34970A-09A-S

S E R V I C E N O T E

34970A Data Acquisition/Switch Unit

POSSIBLE SHOCK HAZARD

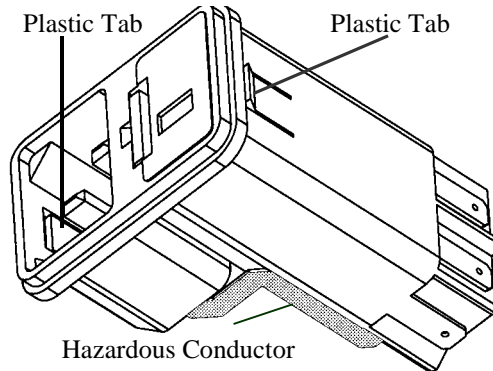
The plastic tabs that secure the AC power connector onto the rear panel of the 34970A can break when subjected to a strong force.

When broken, this connector can be easily moved to expose the line voltage conductors of the damaged AC connector. These exposed conductors are an electric shock hazard to the user.

Damage to the plastic tabs on the AC power connector may occur when moving the 34970A without removing the power cable or when forcefully pulling the power cable out of its connector.

Part 34970-89901 adds external support to the AC power connector. All products with the above serial numbers should be modified with this part to reduce the risk of electric shock to the 34970A user.

The installation process takes less than five minutes and does not require entry into the product enclosure. Only the rear bezel needs to be removed to install the part. Installation instructions are included with the part.
